Re: Applicant: LG Electronics USA

FCC ID: BEJ9QK-WN7111B

Declaration Letter

4M Change Approval Request Report

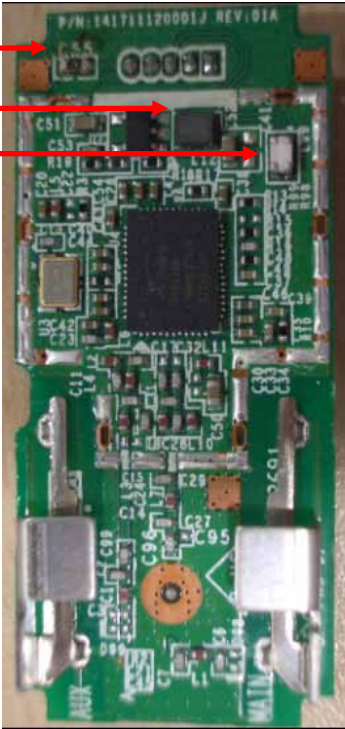
We, LG Electronics USA request permissive class 2 change for the WLAN Adapter card under FCC ID: BEJ9QK-WN7111B, model name WN7111B. For this application, WN7111B is modified to some components not related to do effect to RF parameter. The differences between this application and original's ID as clarified in following page and refer to different of Schematic file.

Before Changing	After Changing
Part number : C55 : 4.7uF, 0603 L12 : 4.7uH, 2.5x2.0x1.2F HITACHI R98,R99 : 0 ohm, 0402	Part number : C55 : 0 ohm, 0603 L12 : 4.7uH, 2.5x2.0x1.2 SUNTECHNIC L99 : Common Filter RFCMF1220100M4 WALSHIN
 A photograph of a green printed circuit board (PCB) before component changes. The board features a central black integrated circuit (IC), various resistors, capacitors, and inductors. Labels 'AUX' and 'MAIN' are visible at the bottom. Red arrows point from the 'Before' image to the 'After' image, indicating the locations of components C55, L12, and R98/R99.	 A photograph of the same green PCB after component changes. The board now includes a common filter (L99) and different capacitors (C55). Red arrows point from the 'After' image back to the 'Before' image, indicating the locations of components C55, L12, and L99. C55 L12 R98/R99 <-> L99
